Detailed Site Plan Alternative Compliance Amber Ridge

DSP-19040 AC-20006

SUBJECT: Detailed Site Plan DSP-19040

Alternative Compliance AC-20006

Figure 3: Proposed Freestanding Sign

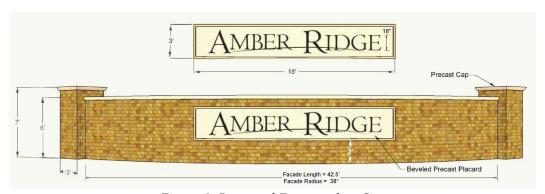
The DSP proposes one freestanding monument sign at the entrance to the development. The monument sign is approximately 5 feet high and 42 feet wide. The sign is brick and includes 7-foot-high columns on each end with a central concrete plaque for the community's name. The sign is externally illuminated using up-lighting. The sign appears to be generally acceptable, and landscaping is proposed behind the sign, but it is noted that attractive year-round landscaping has not been proposed at the base of the sign. Staff recommends that it be included to enhance the proposed signage, as conditioned herein. In addition, staff notes that a schedule has not been provided listing the square footage of the proposed sign. Therefore, a condition has been included in the Recommendation section of this report requiring that a signage area schedule be provided.

- b. Provide attractive year-round landscaping at the base of the gateway sign.
 - c. Provide a schedule clearly indicating the area of the proposed entrance sign.
